PROPOSED AMENDMENT TO NATIONAL POLLUTANT DISCHARGE ELIMINATION SYSTEM PERMIT CA0102695, BOARD ORDER NUMBER R6T-2008-0022, FOR THE SUSANVILLE SANITARY DISTRICT WASTEWATER TREATMENT PLANT, LASSEN COUNTY (WDID: 6A181554001)

**ORDER NO. R6T-2008-0022-A01(PROPOSED)
NPDES NO. CA0102695
WDID 6A181554001**

**AMENDMENT TO WASTE DISCHARGE REQUIREMENTS FOR THE
SUSANVILLE SANITARY DISTRICT, WASTEWATER TREATMENT PLANT
DISCHARGES TO THE JENSEN SLOUGH VIA OUTFALL 001, LASSEN COUNTY**

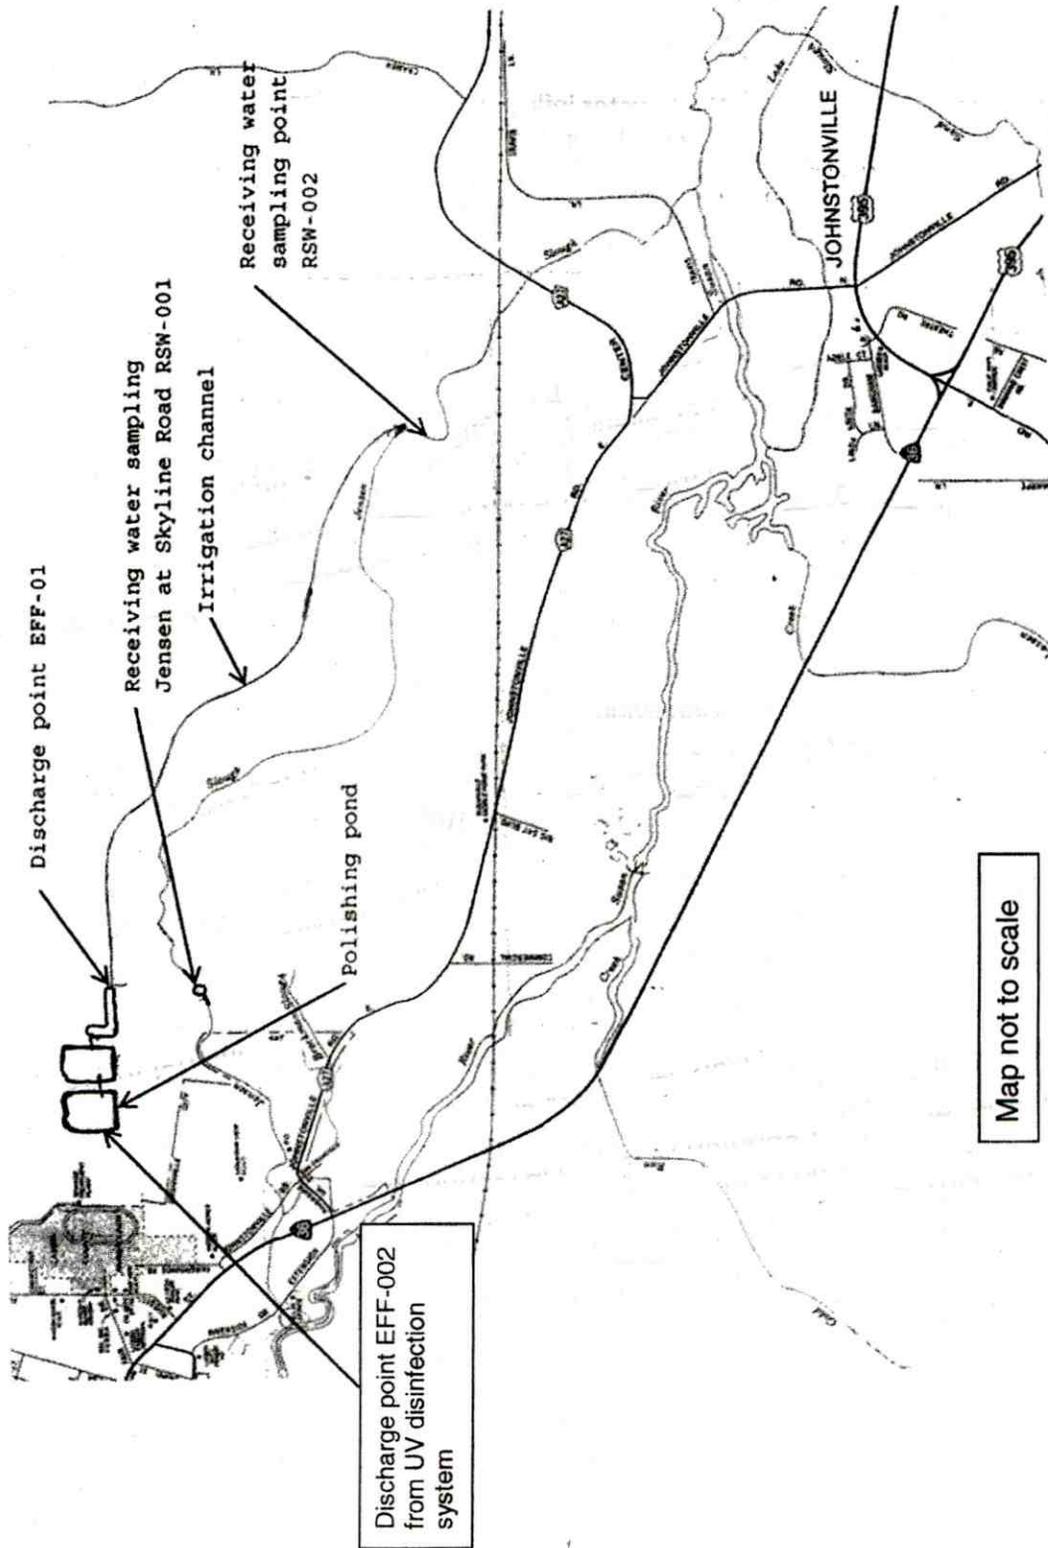
- 1 Change to Attachment B, page B-1 of Order No. R6T-2008-0022; the new page will read as identified in Attachment B to this Order that now identifies the Discharge Point EFF-002 from the UV disinfection system.

- 2 Change to Attachment C2, page C-2 of Order No. R6T-2008-0022; the new page will read as identified in Attachment C2 to this Order that now identifies the Discharge Point EFF-002 from the UV disinfection system, renames the old EFF-002 as EFF-002-CL for when the chlorine system is in use, and identifies discharge point EFF-001.
